EXTERNAL PEER REVIEW OF EPA'S DRAFT REPORT ON DEVELOPMENT OF AN OVERARCHING BIOAVAILABILITY MODELING APPROACH TO SUPPORT US EPA'S AQUATIC LIFE WATER QUALITY CRITERIA FOR METALS

FINAL PEER REVIEW REPORT

August 26, 2021

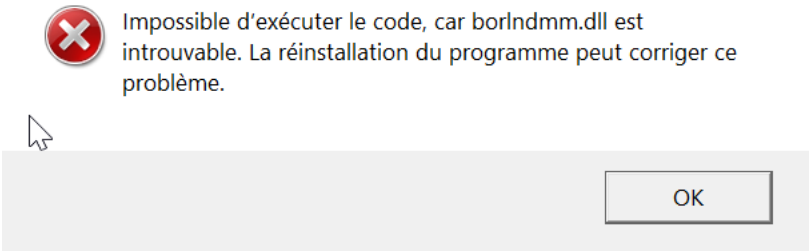
2.1.c	**Appendix G - applying the models for the specific calculations of water quality criteria presented in terms of:** **i. Complexity and transparency** **ii. Representativeness** **iii. Rigor** **iv. Usability**
	Copper – Could not find the executable file at first but was able to recover it from FTP after sending out a request to ERG. I was able to reproduce the results from the answer key without difficulties. A few other observations: The name of the model suggests that it's chronic only, but the output file contains headers referring to "acute values". This can be a source of confusion for users. Being able to switch from one language to another is a nice option. Thanks! Program executes smoothly and quickly compared to Al or Ni. MLR equation easy to spot compared to other metals. MLR provides higher values, especially in the lower range. Models seem to agree in the higher range. **Lead** – Program (BLM_UI.exe) won't load. I tried two different computers and using different folder locations. Error message:

Apparently, I am missing a DLL file. **Nickel** – the BLM model took about a minute to load, I was getting the impression the computer had crashed or that the program was not responding. I didn't have this problem with the Al model. I used default settings which specifies "BLM" and "Chronic". The output file was entitled "Ni test BLM_Chronic.output.xls". The headers of the last two columns were: HC5 (Lognormal Dist.) US EPA FAV There were two confusing elements here. First, this was a simulation for a chronic exposure so I assume that the last header should read "US EPA FCV". Second, when comparing with the "key" data file, the HC5 columns did not match those of the output file. But the values given in the output file under the header "US EPA FAV" had the exact same values as those of the "key"

An example of how natural, daily swings in pH can cause wild swings in criteria that rely on pH as a modifying factor. If the discharger wants a high criteria value that's easy to comply with, they should sample in late afternoon (pH 8.7, Cu CCC 26 µg/L). If zealous regulators want a low

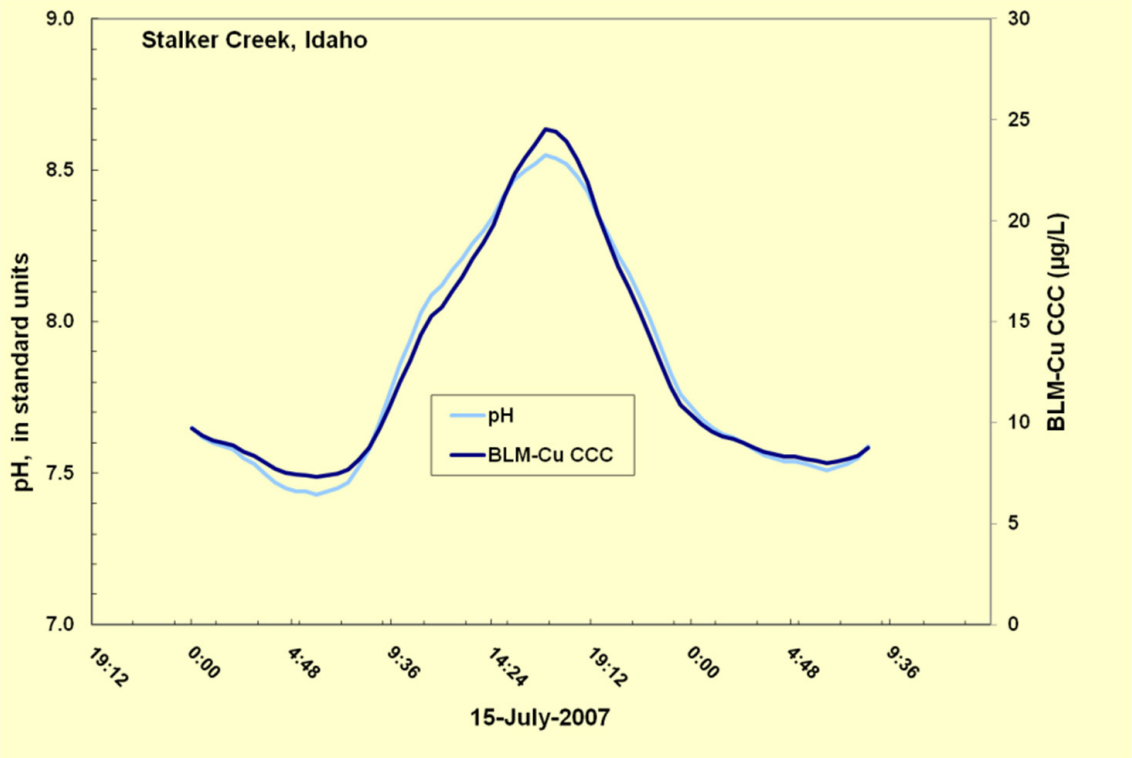
2.5 Additional suggestions that would improve the report.	
Reviewer	**Comments**
	sampling which might not give the most representative results. In a stream contaminated with Zn (primarily) and subject to daily Zn and pH swings, the observed toxicity to trout corresponded best to the daily average conditions, not the daily maximum (worst case) concentrations (Balistrieri et al. 2012). I recommend saying something about the uncertainty of daily pH cycles and the need to resolve the most representative time of day (or daily average) for sampling. With DOC, there has been lots of research and debate on different characteristics that affect metal binding and bioavailability, such as that terrestrial sources with high fulvic/humic acid content reduce Cu bioavailability more than autochthonous sources such as algae senescence. However, I have seen much less in the BLM and metals bioavailability literature about the importance of basic QC in collecting and analyzing DOC. In particular, filtration and tubing can be a real bugaboo that introduces DOC at biologically and BLM-relevant concentrations. I show a few examples of the issue in figure 2 and figure 3. In my group, while we think we are reasonably careful and attuned to the issue, we still sometimes see DOC in filter blanks at 0.2 to 0.3 mg/L, even though the manufacturer of the organic blank water that we purchase certifies that the water contains <0.05 mg/L TOC. We're probably picking up some DOC through the filters and tubing during filtering. Yoro et al. (1999) is a good citable citation on this point.

2.5 Additional suggestions that would improve the report.	
Reviewer	**Comments**
	criterion value, they should sample late at night or early in the morning when pH is low (pH 7.5, BLM based CCC 8 µg/L). So what to do? Take the average?

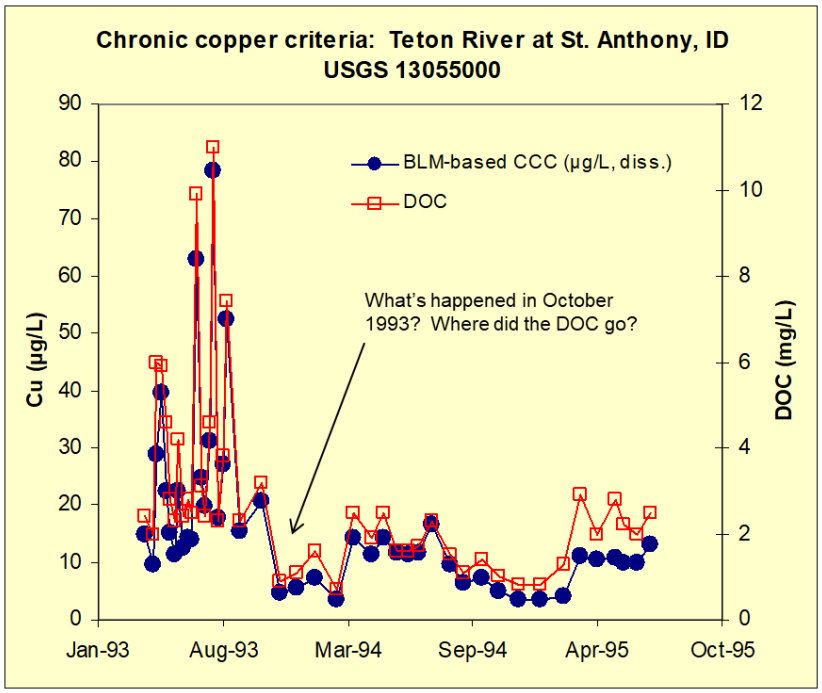
2.5 Additional suggestions that would improve the report.	
Reviewer	**Comments**
	Another example of how filtration and cleaning practices can create bad DOC data, which can be hard to catch on a sample by sample basis. In this case, DOC contamination was suspected to have been caused surfactants residual to the capsule filter manufacturing process and inadequate flushing before the sample was taken. My point in all this is that either in the main document or in appendix B it would be prudent to say something about the importance of good sampling and measurement practices with the inputs to these models, and in particular pH and DOC. I suggest it could be a lot shorter than my examples and cite on the pH issue studies like Balistrieri et al (2012) and maybe Nimick et al (2011), and Yoro et al. (1999) on the DOC issue. As these models move towards criteria, it would be good to include some recommended practices on these mundane but important issues of data representativeness and quality. **Copper** **Cu and Hardness.** *"There is a consistent protective effect of water hardness on Cu toxicity in acute and chronic exposures to fish and invertebrates ... with equivocal results or no protection in only a few studies."* That seems a little overstated and I would reword it to be more even handed. Something like 'Many studies reviewed have shown some protective effect of water hardness on Cu toxicity in acute and chronic exposures to fish and invertebrates (for example, cite; cite; cite;...). However, inconsistent results or no protection were reported in some studies, for example (Chapman et al. 1980; Richards and Playle 1999; De Schamphelaere and Janssen 2004b; Hyne et al. 2005; Markich et al. 2005; Wang et al. 2009) **Zinc** **Zn and Hardness** – I can't help but chime in with a "us too." In Mebane et al. (2012), we reported 4 tests with rainbow trout, each with fish from the same cohort in different natural waters. Hardness explained between 90% to 99% of the variability in EC50s in these natural waters where pH was allowed to covary. **Zn and DOC**. I think the story with DOC protecting against Zn toxicity is more nuanced and equivocal than this paragraph would lead readers to believe. In particular the sentence "*In freshwaters, dissolved organic matter (DOM) – quantified as dissolved organic carbon (DOC) – generally decreases Zn bioavailability (e.g., Hyne et al. 2005; Clifford and McGeer 2009; Heijerick et al. 2003).*" First, that is not what Hyne et al (2005) reported. Rather, they reported that the addition of 10 mg/L DOC only resulted in a very small (1.3-fold) reduction in the toxicity of zinc to Ceriodaphnia, whereas the same DOC addition resulted in a 45-fold reduction in Cu toxicity. I have seen no reports of DOC having an important role in reducing Zn toxicity until DOC concentrations are fairly high (greater than at least 5 mg/L DOC and probably greater than 10 mg/L DOC). The minimum DOC tested by Heijerick et al was 9 mg/L. Clifford and McGeer (2009) tested a base condition with 0.6 mg/L DOC, 6-7 mg/L DOC additions, and 10-11 mg/L DOC added. Only the pair of high DOC additions (10-11 mg/L) reduced toxicity beyond the range of the base conditions with 0.6 mg/L DOC. In tests of the acute toxicity of Zn to sturgeon, DOC in the range of 1 to 5 mg/L had no effect (Ivey et al. 2019). In tests with fathead minnow and Zn under different organic carbon conditions, a threshold concentration of 11

2.5 Additional suggestions that would improve the report.	
Reviewer	**Comments**
	mg/L DOC was required to reduce acute toxicity to (Bringolf et al. 2006). The take home on Zn-DOC toxicity relations from published research is that DOC concentrations <10 mg/L are sparse, and from what I can find indicates little protective effect for Zn toxicity. The significance of this to the MLR approach is that if there is a threshold effect for DOC reductions at around 10 mg/L, a linear regression that predicts a linear response may be misleading and underprotective in the low range between say 0.5 and 10 mg/L. A regression that fits a straight line from controls with say 0.5 mg/L to 40 mg/L, will show a strong response, and give the same slope in the 0.5 to 10 mg/L DOC range of the regression as in the higher DOC range, even though no data were in the low range. It's just fitting a straight line. For instance, in the Heijerick et al. (2003) study mentioned above, they have a very clean plot predicting a linear response between DOC and Daphnia toxicity (their figure 3). However, the underlying data included test pairs with huge ranges. One test pair had pH 7.25, hardness 240 and DOC of 2 vs DOC 40 mg/L; one test pair had pH 6, hardness 110 and DOC of 9.7 vs 32 mg/L; and the third test pair was with pH 8, hardness 370 and DOC 9.7 vs 32 mg/L. None of those tests tell us anything about what is going on at the low 1-5 mg/L DOC values, although one wouldn't immediately realize that from the pretty model plot in their Figure 5. The reason for this concern with the potential overextrapolation of DOC-Zn toxicity relations to the range of ≈ 0 to 10 mg/L, is that that is the range where the vast majority of flowing waters in the US fall. USEPA (2016b) included a summary of DOC values collected from 1,392 sites sampled across the 84 ecoregions of the United States using a probability-based sample design from the EMAP Wadable Stream Assessment (WSA). The median values for each of the 84 ecoregions were reported. The 90th percentile of the 84 ecoregions was 8.4 mg/L, the 75th percentile was 5.2 mg/L, and the national ecoregional median was 2.7 mg/L DOC (calculated from table 17 of USEPA (2016a)). Thus >90% of the streams in the United States would be expected to have DOC values in the range of questionable Zn-DOC relations. Thus, the usual MLR straight line approach may not be the most appropriate for Zn and DOC and a nonlinear function or a piecewise 'nonlinear' function may need to be explored. **Appendix C comments** I just glanced through "*Appendix C, Table 2: Supporting Information for Bioavailability Model Comaprison Table*" First, I think "comaprison" is a fine new word that should be added to the spell checker and kept in the report, applicable to the state of mind in many an office cube. Well, maybe it should be hyphenated, coma-prison. A couple other items that caught my eye... First row, Aluminum BLM: No reference is given, but the version "3.18.2.42" looks like a Windward numbering version. Santore et al (2018) describe using CHESS and WHAM V, not WHAM 7. To my knowledge, no Windward BLM version has incorporated WHAM 7. Cobalt BLM says it is "complete" but to my knowledge no Co BLM has been formally published or publicly released online. The version "3.15.2.41" also looks like Windward numbering, which makes me wonder whether it actually used "WHAM 6" for speciation, since as with WHAM 7, that would have been a big coding project. I would check this.

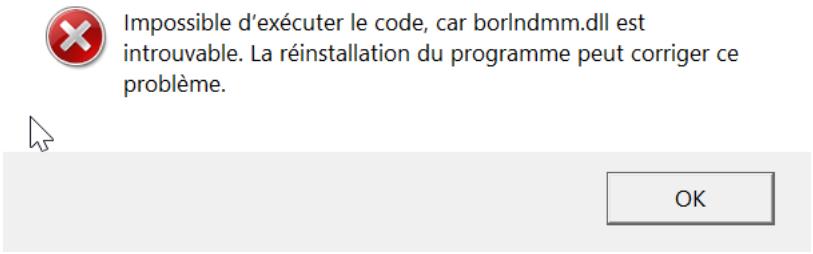
Lead – Program (BLM_UI.exe) won't load. I tried two different computers and using different folder locations. Error message:

Apparently, I am missing a DLL file.

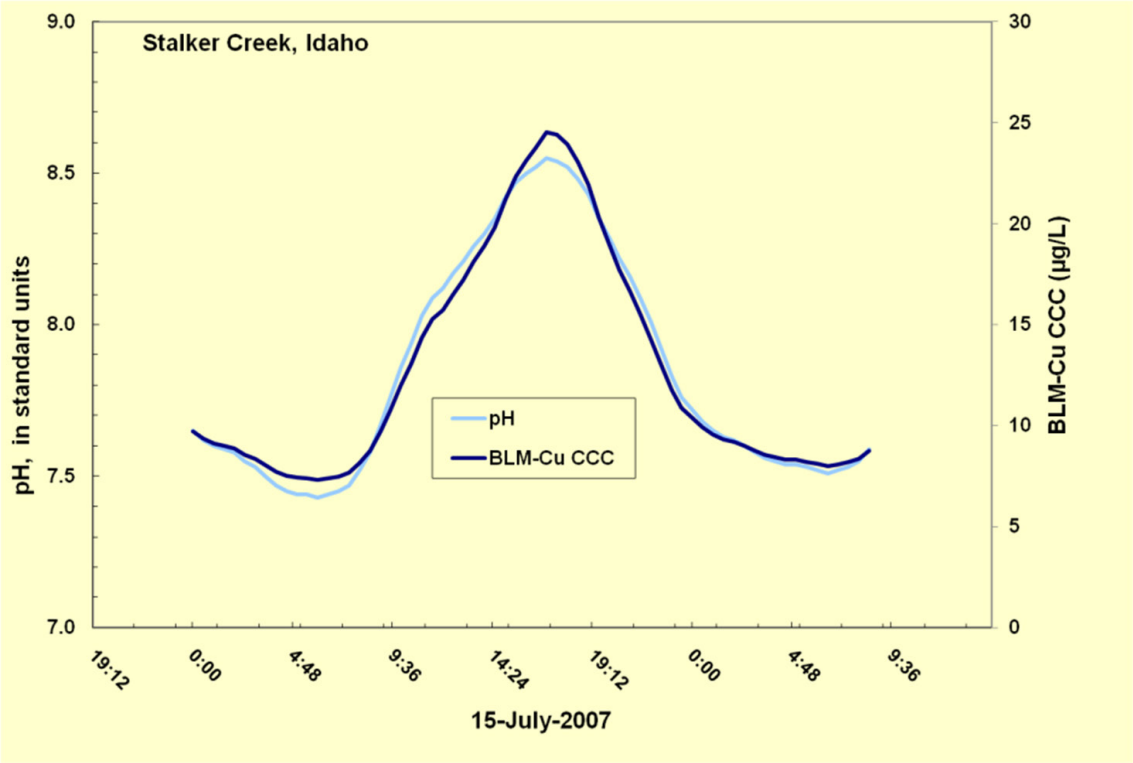
Appendix B reflects a big effort and is a very helpful, concise guide to much relevant information for the subset of metals supported through the CRADA efforts. While hardness is hard to screw up, I do suggest adding a bit on the importance of data quality in pH and DOC data. pH probes are notoriously finicky. More importantly, in some waters the daily cycles of production and respiration can cause pH swings high enough to skew criteria a lot. Even ~0.2 units can make noticeable differences in criteria calculations and natural swings of >1 unit aren't unheard of. Figure 1 gives an example calculation where the criteria would swing 3-fold from 8 to 25 µg/L over the course of a day. So when should waters be sampled? Depending on the desired answer? Most likely, whenever it's most convenient for the person doing the sampling which might not give the most representative results. In a stream contaminated with Zn (primarily) and subject to daily Zn and pH swings, the observed toxicity to trout corresponded best to the daily average conditions, not the daily maximum (worst case) concentrations (Balistrieri et al. 2012). I recommend saying something about the uncertainty of daily pH cycles and the need to resolve the most representative time of day (or daily average) for sampling.

DOC. In particular, filtration and tubing can be a real bugaboo that introduces DOC at biologically and BLM-relevant concentrations. I show a few examples of the issue in figure 2 and figure 3. In my group, while we think we are reasonably careful and attuned to the issue, we still sometimes see DOC in filter blanks at 0.2 to 0.3 mg/L, even though the manufacturer of the organic blank water that we purchase certifies that the water contains <0.05 mg/L TOC. We're probably picking up some DOC through the filters and tubing during filtering. Yoro et al. (1999) is a good citable citation on this point.

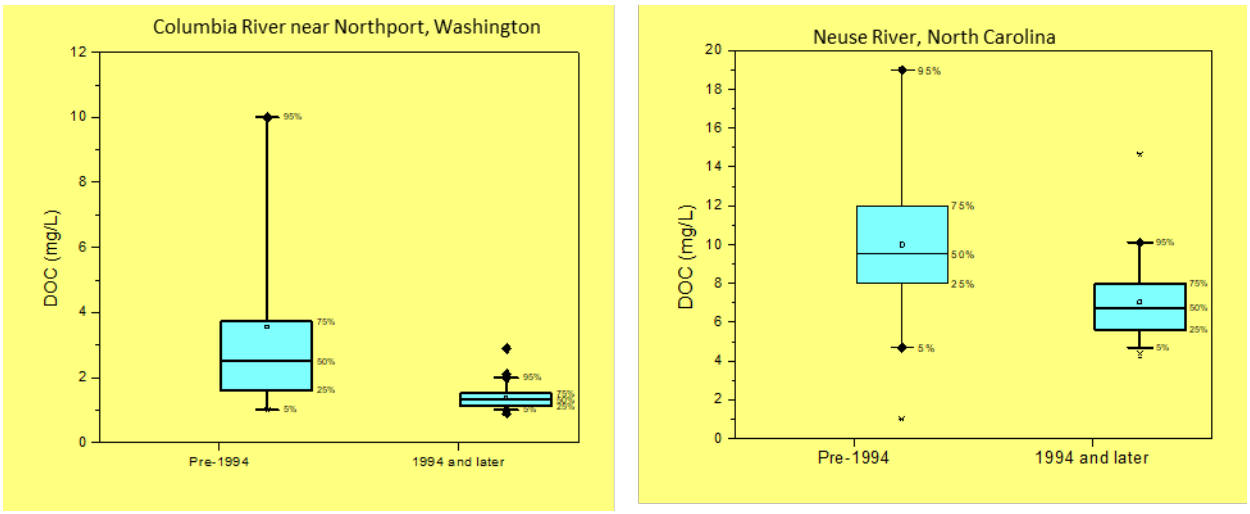
With DOC, there has been lots of research and debate on different characteristics that affect metal binding and bioavailability, such as that terrestrial sources with high fulvic/humic acid content reduce Cu bioavailability more than autochthonous sources such as algae senescence. However, I have seen much less in the BLM and metals bioavailability literature about the importance of basic QC in collecting and analyzing

Figure 3. Another example of how filtration and cleaning practices can create bad DOC data, which can be hard to catch on a sample by sample basis. In this case, DOC contamination was suspected to have been

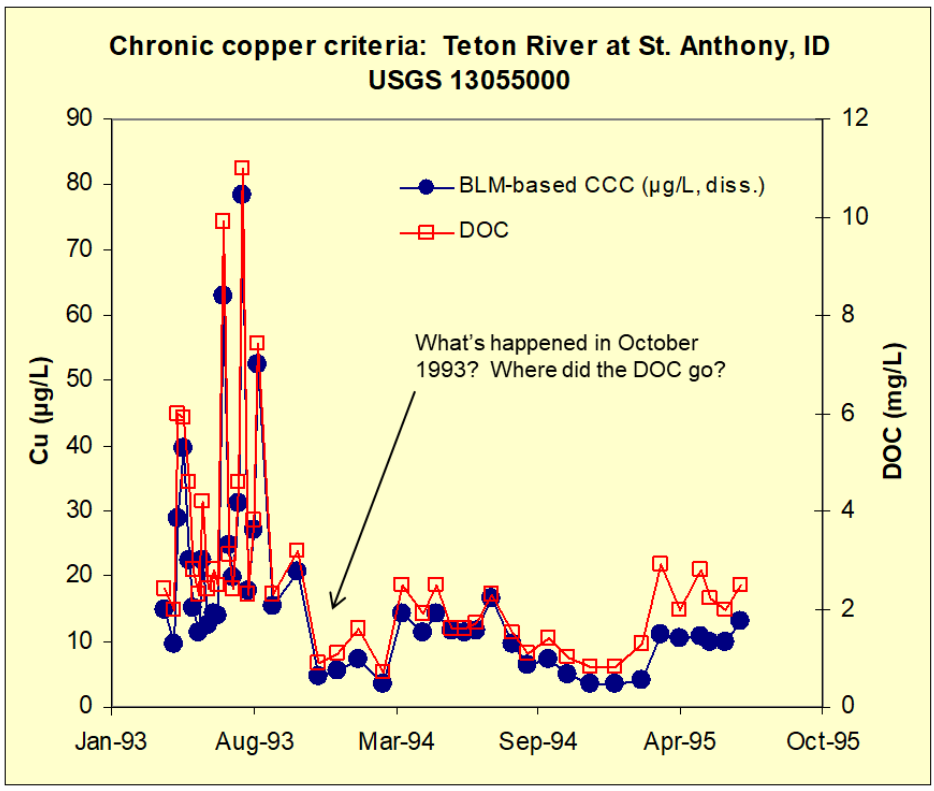
caused surfactants residual to the capsule filter manufacturing process and inadequate flushing before the sample was taken.
